Access Compliance Report Public Rights-of-Way (Curb Ramps)

Main Street: HUNTRIDGE_RD		Cross Street: RYCROFT_RD		Location:	NE
ADA ID: RPRK211012134322	Ramp Type: Type 4 - Parallel	Initial Pass/Fail: Fail	Overall Compliance: No	Severity Score:	15

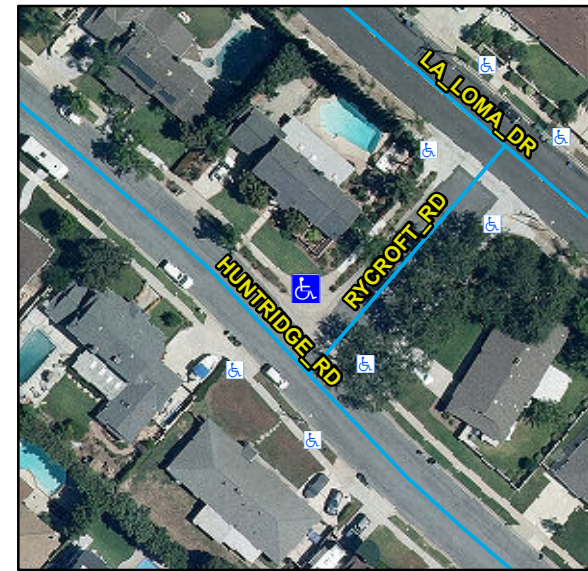
Compliance	Description	Data	Compliance	Description	Data
N/A	Ramp Length LT (in)	124	N/A	Ramp Length RT (in)	124
Yes	Ramp Width LT (in)	106	Yes	Ramp Width RT (in)	106
Yes	Ramp Run Slope LT (%)	3.3	Yes	Ramp Run Slope RT (%)	7
No	Ramp Cross Slope LT (%)	6.6	No	Ramp Cross Slope RT (%)	5.7
N/A	Landing Present	N/A	N/A	DWS Provided	N/A
N/A	Landing Length (in)	N/A	N/A	DWS Contrast	N/A
N/A	Landing Width (in)	N/A	N/A	DWS Length (in)	N/A
N/A	Landing Run Slope (%)	N/A	N/A	DWS Full Width	N/A
N/A	Landing Cross Slope (%)	N/A		DWS Offset Type	N/A
N/A	Landing Movement Obstructed?	N/A	N/A	DWS Offset Left (in)	N/A
	Landing Movement Type	N/A	N/A	DWS Offset Right (in)	N/A
N/A	Landing Shared	N/A			
N/A	Clear Space	Yes			
N/A	Clear Space To Crosswalk (in)	N/A			
N/A	Marked Crosswalk 1	No	N/A	Marked Crosswalk 2	No
	Crossing 1 Direction	W		Crossing 2 Direction	S
	Marked Crosswalk 1 Width (in)	N/A		Marked Crosswalk 2 Width (in)	N/A

Remove & Replace Curb Ramp With Two New Directional Ramps or Equivalent.
